DC/21/2503/OUT – Land South of Forge Close, Benhall

Consultation on revised Access proposals: October 2024

Benhall & Sternfield Parish Council

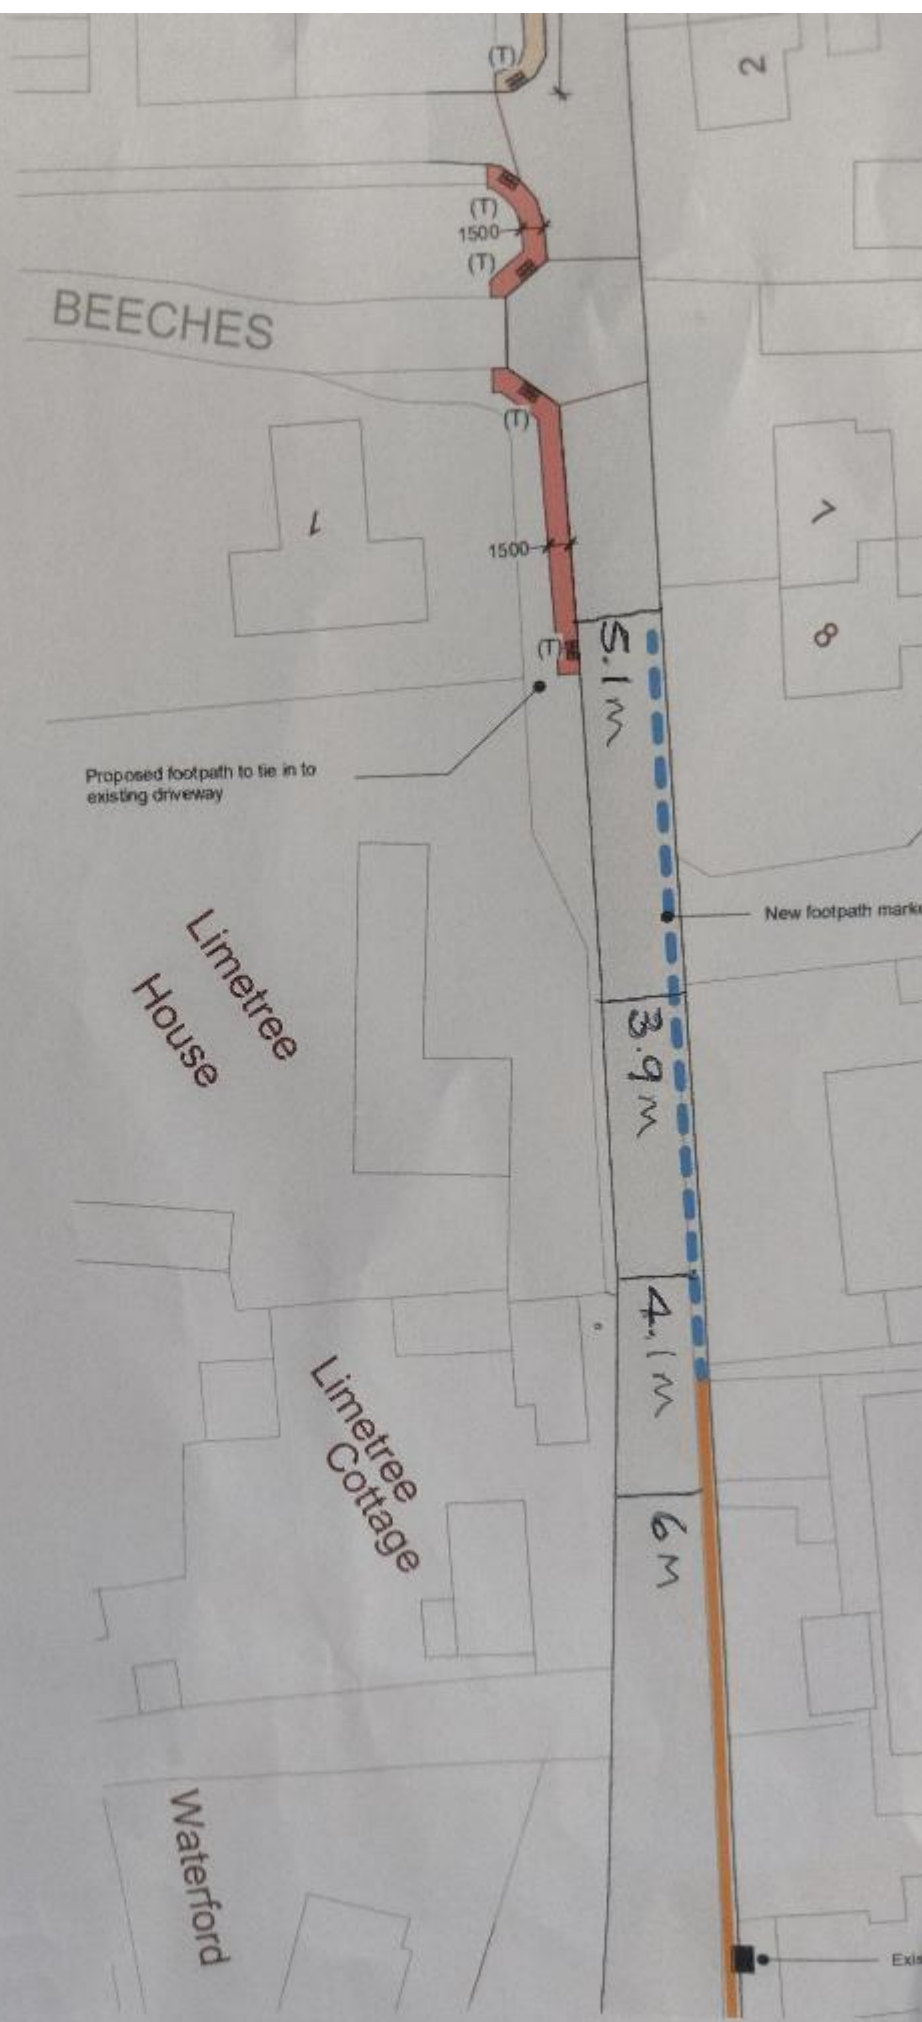
- a) It has reduced the pedestrian permeability from that proposed in August 2023 by leaving footpath 26 as a footpath. It should be upgraded to a surfaced bridleway as shown on those plans and this bridleway should be extended into Mill Lane ie a fully surfaced bridleway for the full length from the B1121 bridge to Mill Lane. This is the only way to meet these criteria.

- b) The route on the latest proposal does provide 'access' to Benhall but in no way enhances permeability. And we are unconvinced about the safety, particularly where the dashed lines are proposed: this road is already a narrow (single car width on occasions) 30mph route to the school and the Benhall Club. It becomes very busy several times a day. The use of dashed lines further narrows the road. Note that buses and sewage tankers also use this route. It may be acceptable as an optional route from this development. It is not acceptable as the only route. Whilst we do not support the white lined pedestrian route from the site to Forge Close, it must be included, but aligned back from the road. See photo below which clearly shows how narrow this road is: dashed lines 1.5 m from the verge leave only 2.4m of roadway at the narrowest point. There is a danger to cyclists, walkers, wheelers at the narrowest sections.

The addition of a field gate implies that the farmer is expecting to manoeuvre farm vehicles through the roads of this new development. If this is needed in order to access the Highway, a full separate Planning Application should be made specifically for this usage.

This development needs to reinstate the upgrade of footpath 26 to a surfaced bridleway, and a continuation to Mill Lane.

Both the pedestrian/cycling/walking/wheeling routes need to have maintenance agreements to ensure they are usable year round.
